NSW GOVERNMENT  
**Department of Planning**

**RE: MP 06\_0034 – 76 and 84 Greenwell Point Road, Greenwell Point and Goodnight Island off Orama Crescent, Orient Point (respectively), Proposed Mixed Use Development**

## ANNEXURE A – ISSUES

Figure 1: Suggested changes to the ground level of Building at No 76 Greenwell Point Road.

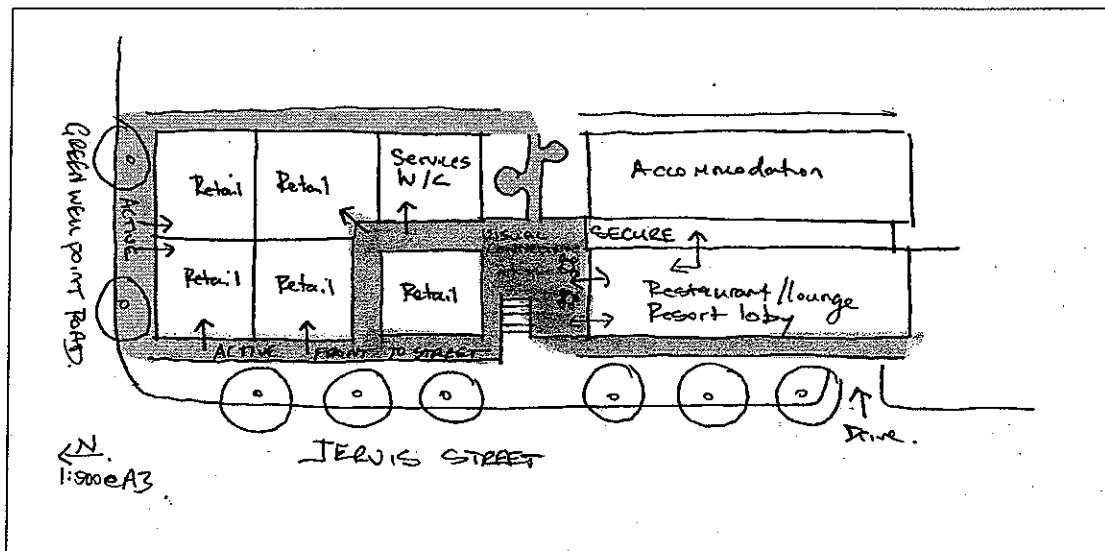
- Access to the west facing retail tenancies along Jervis Street would be better located on the outside of the building along the Jervis Street elevation. The strip currently reserved for a garden could be widened to at least 3.2m to allow for circulation, allowing access to the retail

shopfronts and providing a level connection between Greenwell Point Road and the hotel entry. These modifications would also improve security by ensuring separation between retail access and hotel reception (see Figure 1 below).
